THRUSTER

service bulletin

☐ WARRANTY INFORMATION☐ PARTS INFORMATION	SERVICE INFORMATION		DN Bul	Bulletin No. 2003-04	
Circulate to: Sales Manager A	ccountina	Service Manager	Technician	Parts Manager

Incorrect Door Knob Bushing On 21/24 Gator Mounts

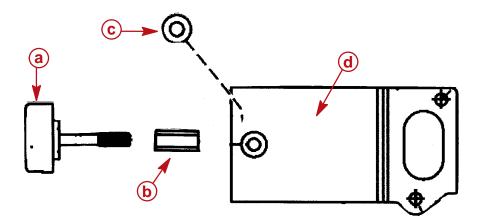
Manufacturing may have installed a plastic door knob bushing on the above listed mounts rather than the normal metal bushing.

If the plastic door knob bushing is found in the above listed mounts, replace the bushing with a metal door knob bushing.

Qty. One (1) MRK02105 door knob bushing

Qty. One (1) MRK17106 washer
